# American Geotechnical, Inc.

April 2, 2021

Subject: **RESPONSE TO CITY OF LAGUNA NIGUEL GEOTECHNICAL REVIEW SHEET DATED FEBRUARY 15, 2021 AND NOTICE OF INCOMPLETENESS DATED FEBRUARY 23, 2021**  
Tentative Tract No. 17721  
The Cove at El Niguel  
30667 Crown Valley Parkway  
Laguna Niguel, California

References: **NOTICE OF INCOMPLETENESS FOR SITE DEVELOPMENT PERMIT SP 16-04 AND TENTATIVE TRACT MAP 17721 (30667 CROWN VALLEY PARKWAY – THE COVE AT EL NIGUEL)**  
By: Community Development Department, City of Laguna Niguel  
Dated: February 23, 2021

31515 AG-26 A

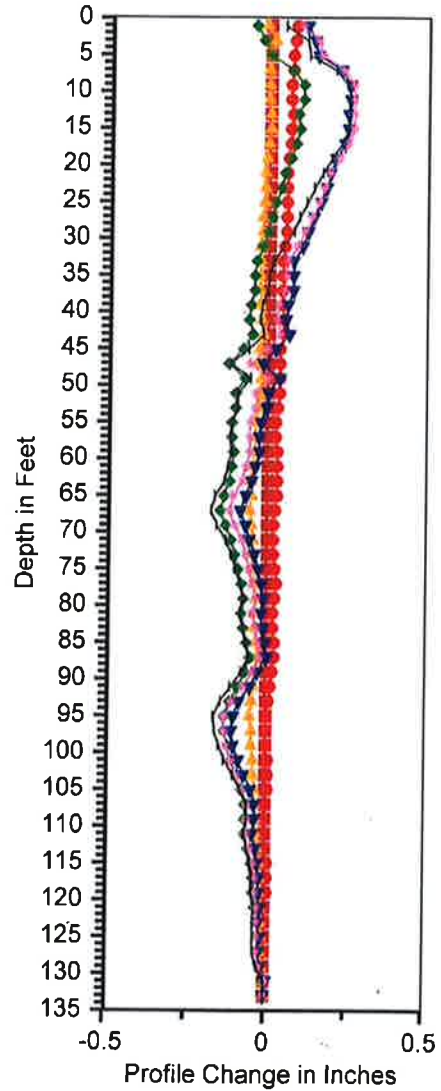
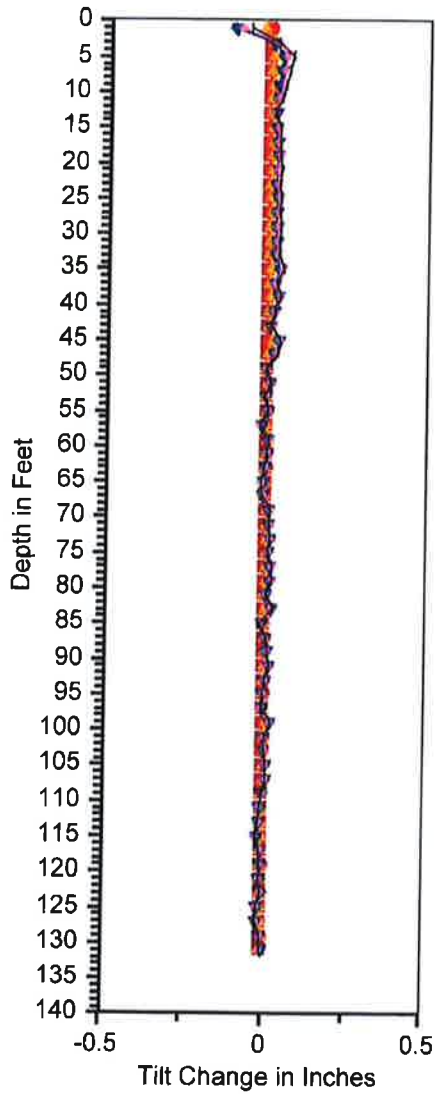
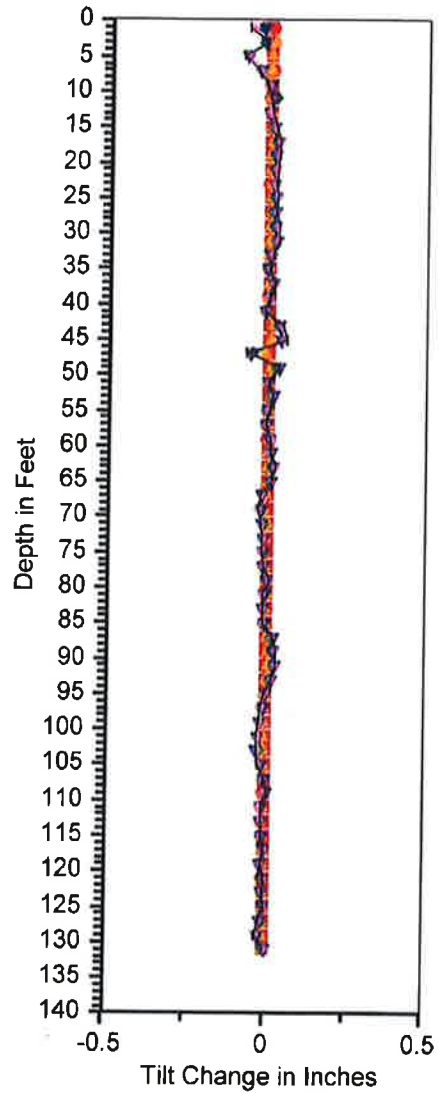
*The report provides inclinometer data for three installations within the property, with readings taken in December 2020. Based on the plots, it appears that on-going movement is occurring to some degree in all three installations. Please provide more discussion on the data, including:*

As discussed in our January 8, 2021 report, our inclinometer data analyses for inclinometer AGI-26 revealed that maximum apparent cumulative displacement at AGI-26 is about 0.81 inches at a depth of 4 feet for over a period of circa 20 years (19.7 years). There is no distinctive movement detected at depths in incremental displacement at the AGI-26 plot location. The behavior is completely consistent with well-integrated creep plus limited drying in the upper about 6 feet. The rate of movement over the past 20 years of the monitoring period at the AGI-26 location is about 0.041 inches per year at a depth of 4 feet. Such a low rate of movement, in our opinion, is attributed to insignificant creep over the monitoring period.

31515 AG-27 A

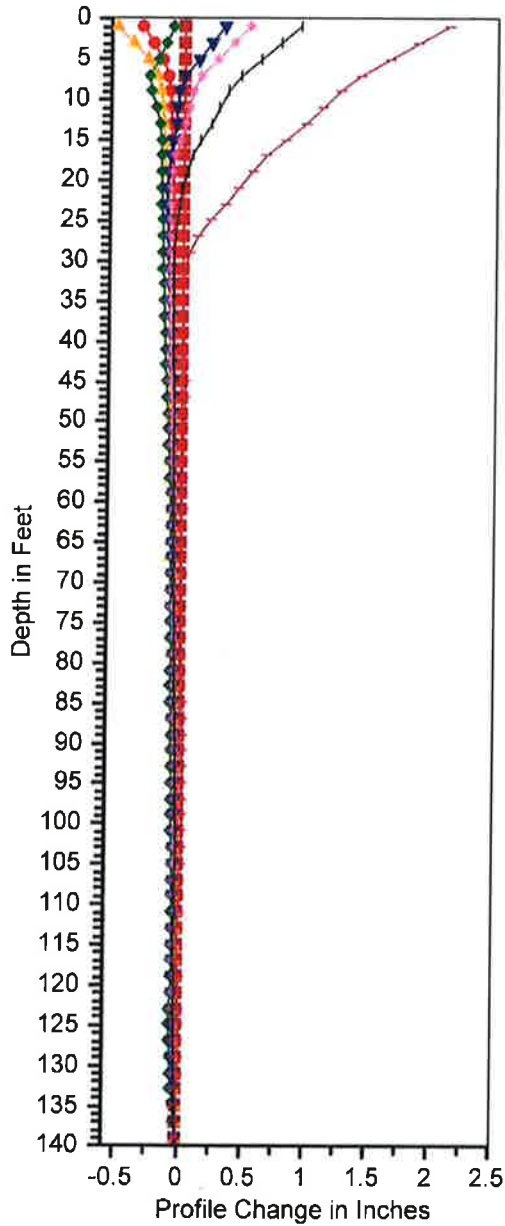
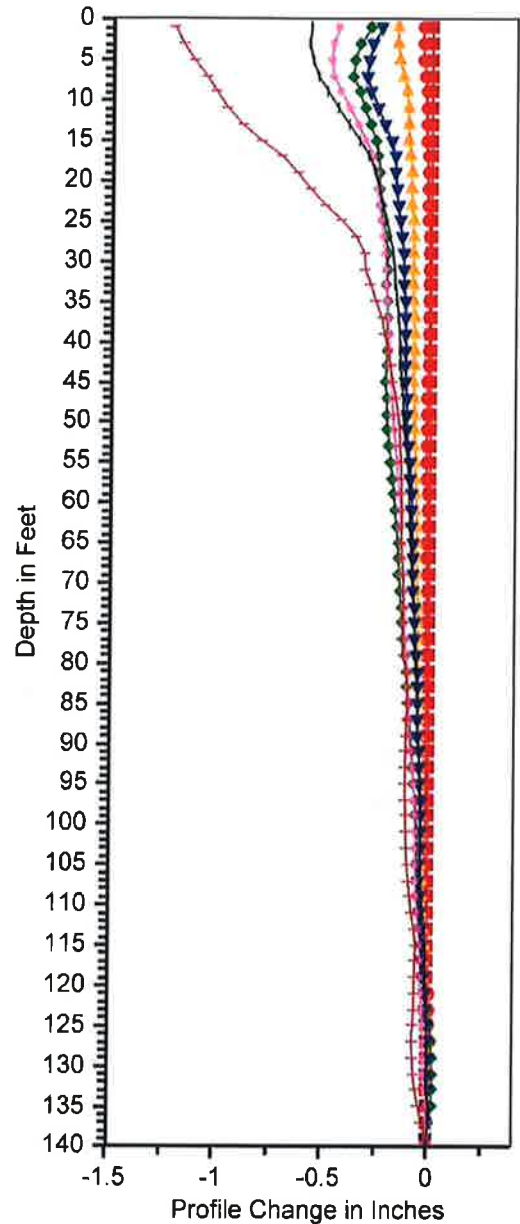
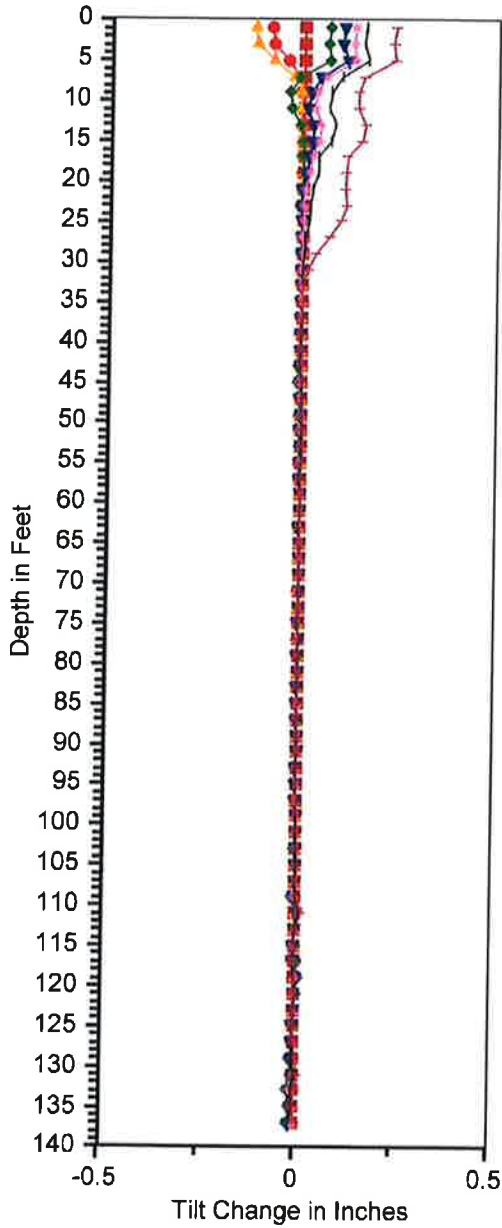
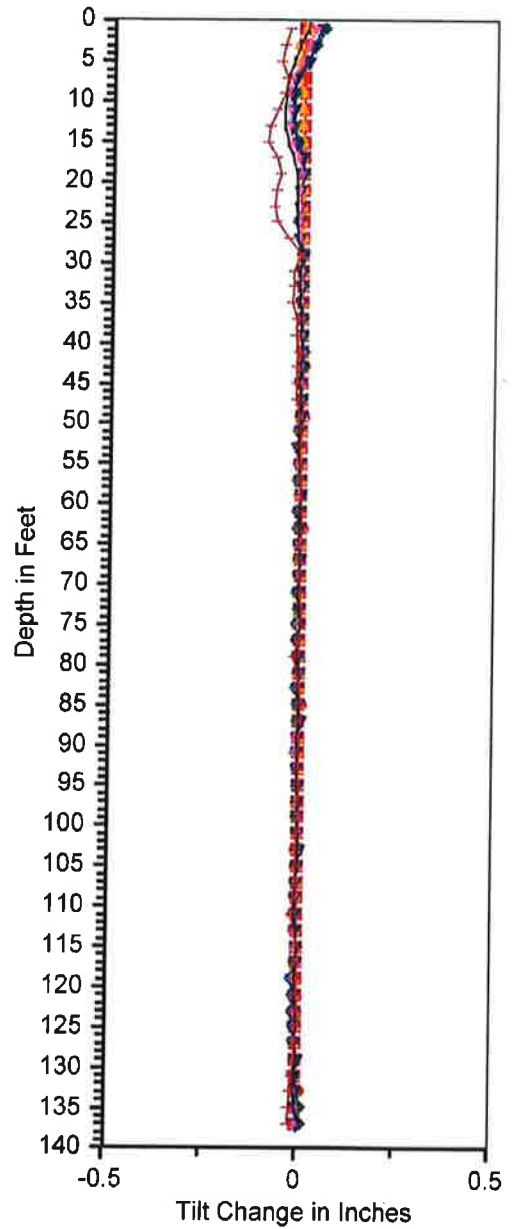
- a. AG-27 shows movement in the upper 30 feet that appears to be continuing, and may be increasing in rate. It is not clear from the cross-sections provided what geologic materials exist at this inclinometer (the inclinometer is projected onto sections that show differing depths of fill). Please provide the log of the boring for this inclinometer. Please also discuss the causal mechanism for this creep, and how it may impact the proposed development, including the MSE wall and adjacent residential units. Will there be any future impact as a result of this on-going movement?*

Our inclinometer data analyses for inclinometer AGI-27 revealed that maximum apparent cumulative displacement at the AGI-27 location is about 2.11 inches at a depth of 2 feet over circa 20 years of the monitoring period or at a rate of about 0.11 inches per year. The behavior of this inclinometer is also consistent with well-integrated, expected creep. Maximum cumulative displacement at the AGI-27 location occurred between the 2016 and 2020 readings, about 1.18 inch at a depth of 2 feet or at a rate of about 0.29 inches per year. The depth of movement is shown at a depth of about 30 feet below the ground surface (bgs) from incremental displacement plot. Although the rate of movement of 0.29 inches per year measured from the 2016 to 2020 readings increases when compared to the overall rate of movement of

0.11 inches per year for the entire almost 20 years of the monitoring period, these low rates of movement are consistent with the rate of creep movement typically seen for the southern California slopes. It appears that the rates of movement, either 0.11 inches or 0.29 inches per year, all reflect a typical creep movement of the highly expansive 1979 fill. The undersigned and American Geotechnical have conducted many projects associated with slope creep influence in southern California including Laguna Niguel. Our experience indicated that for a typical southern California slope, rate of movement in response to slope creep is generally on the order of about 0.1 to 0.3 inches per years. The rate of movement at the inclinometer AGI-27 location is within the typical range of creep movement in southern California.

### 31515 AG-31 A

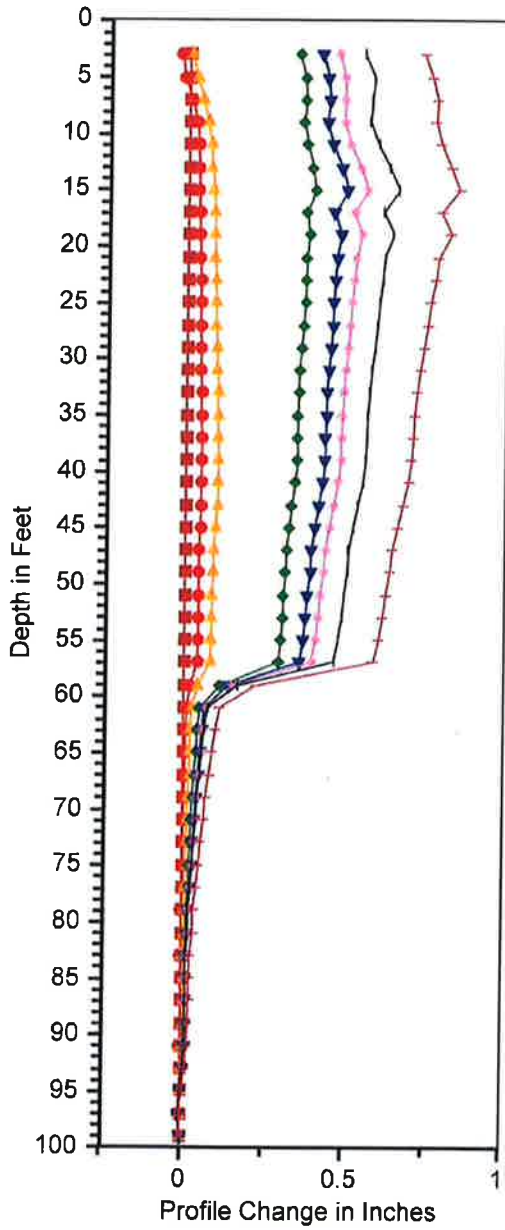
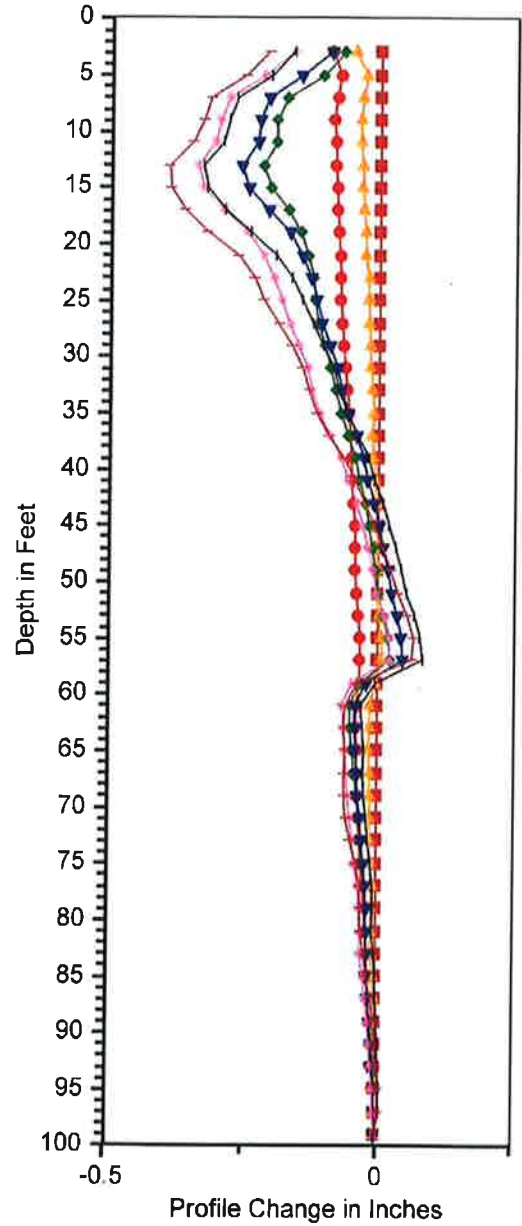
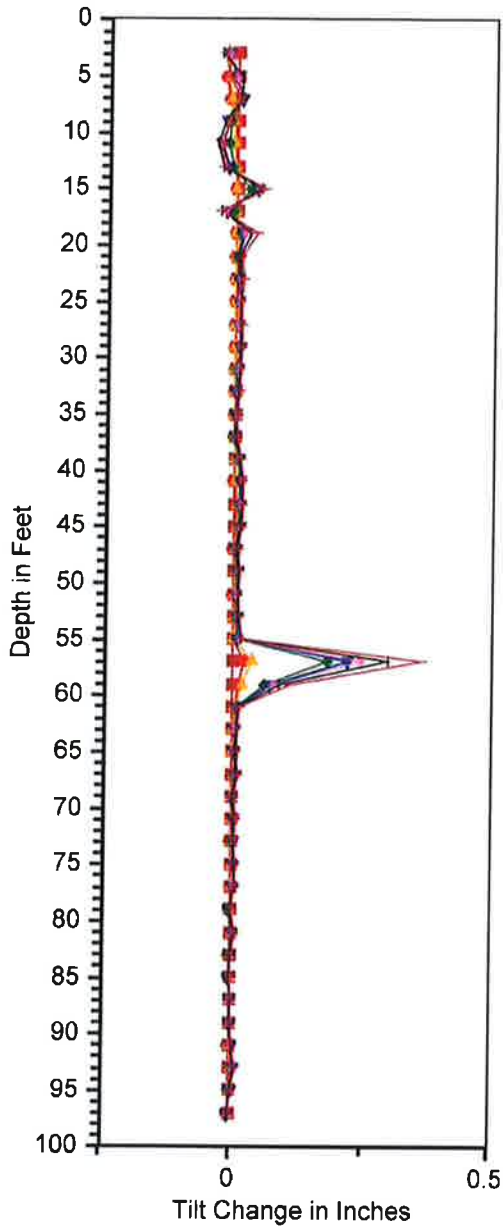
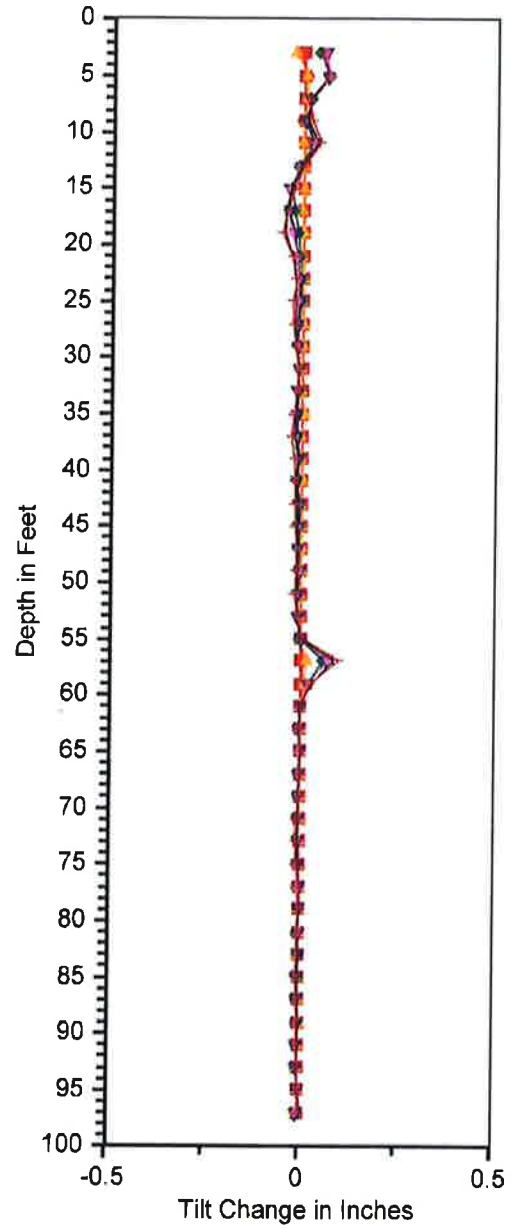
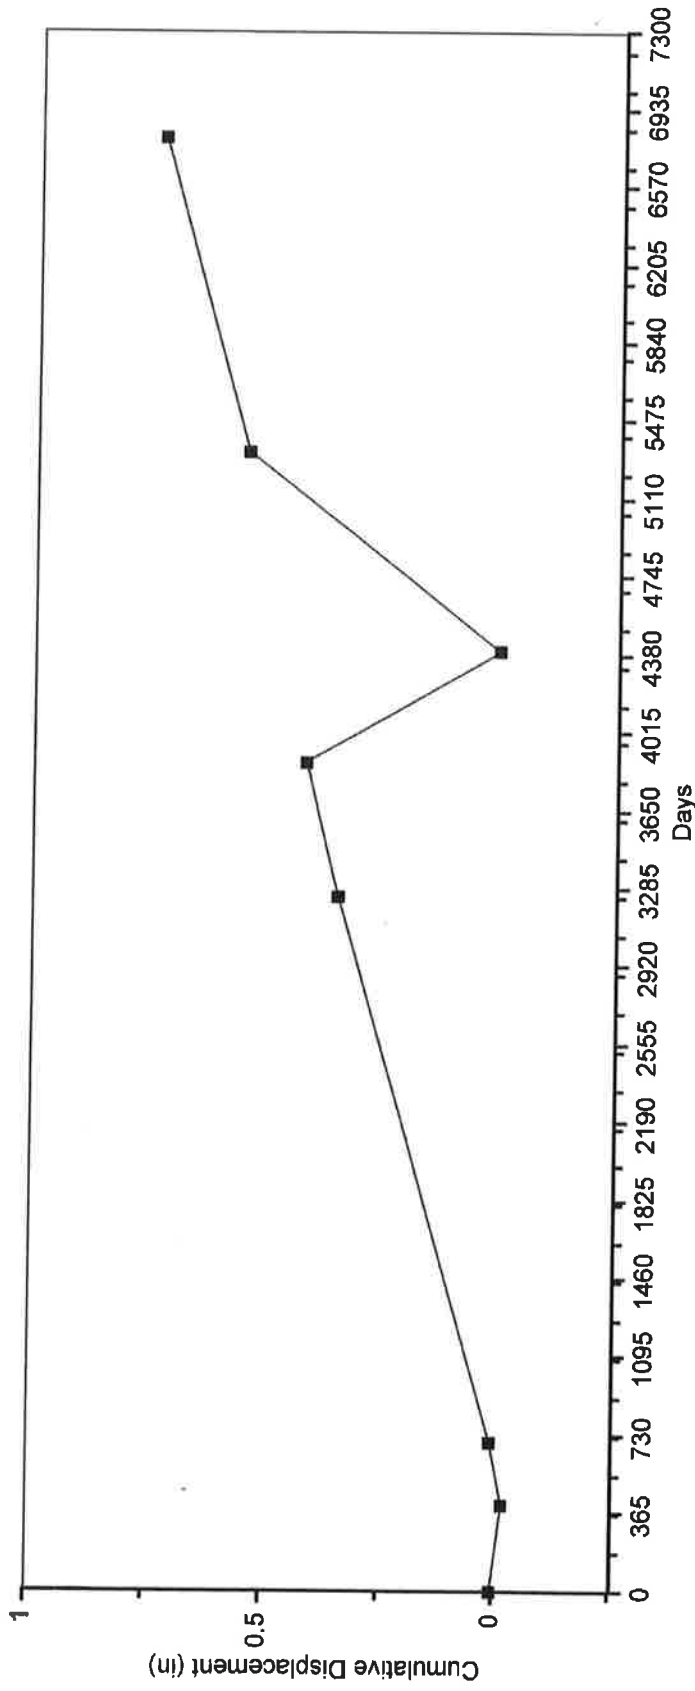
- b. AG-31 shows on-going movement at about 57 feet that has not decreased in rate. The consultant's letter dated October 23, 2013 attributed this movement to the landslide mass "coming to equilibrium and corresponding, mobilization of capacity within the buttress mass." The current report attributes this movement to "casing anomaly", which does not appear to be correct. It appears that the landslide mass is continuing to move. Please discuss this on-going movement, and any potential impacts to the proposed development. Will there be any future impact to the proposed development as a result of this on-going movement?*

Our inclinometer data analyses for inclinometer AGI-31 revealed that maximum apparent cumulative displacement at the AGI-31 location is about 0.85 inches over a depth of about 15 feet below ground surface (bgs) or at a rate of 0.045 inches per year in the direction of the positive A-axis with a trend of S48E. Maximum apparent cumulative displacement at depth of 57 feet bgs is about 0.59 inches over roughly 19 years or at a rate of about 0.03 inches per year. Minor movement at a depth of about 57 feet bgs is visible in both the positive A and B directions in the incremental displacement plot. Maximum incremental displacement is about 0.365 inches over roughly 19 years in the positive A direction and 0.1 inches in the positive B direction. Incremental displacement at a depth of 57 feet bgs has shown uniformly increase of rate of movement over roughly 19 years (18.6 years) since the baseline reading taken on May 2, 2002.

Our review of the boring log for inclinometer AGI-31 revealed that there is about 60 feet of fill soil consisting of olive green/olive brown, slightly moist to moist, firm Silty CLAY underlain by FORMATION consisting of light brown, very moist, soft to firm Silty CLAY. Water at a depth of 52 feet bgs was noted after 30 minutes of drilling and seepage was observed at a depth of 60 feet bgs.

A "blinders-on-view" of the inclinometer AGI-31 behavior at depth of about 57 feet did catch our attention as well as the reviewer's attention. Closer examination reveals circumstances/conditions that put that initial concern to rest for the following reasons:

- 1- The offset is in fill (at depth of about 57 feet), not in bedrock (bedrock contact is at depth of 60 feet).
- 2- The rate of movement is essentially linear but incredibly slow (i.e., 0.03 inches per year).
- 3- The observation is occurring where the inclinometer casing is buckling (see B-axis behavior in cumulative displacement plot).

- 4- No nearby inclinometers (i.e., AGI-26 and AGI-27) have similar behavior which indicated that passive resistance is locally still being mobilized in the fill downslope from AGI-31. Because the movement is so incredibly slow, about 0.03 inches per year, it can take decades to fully develop the available passive resistance. Calculations; however, clearly show adequate factors-of-safety.

At a creep rate of only about 0.03 (at depth of 57 feet) to 0.045 (at near surface) inches per year at the AGI-31 location, no unusual behavior is indicated. Similar at-depth creep movement was not observed in any of the further downslope inclinometers (i.e., AGI-26 and AGI-27 locations) as discussed earlier. In other words, it is our opinion that the fill buttress constructed during the Via Estroil (Niguel Summit) Landslide is performing rather well.
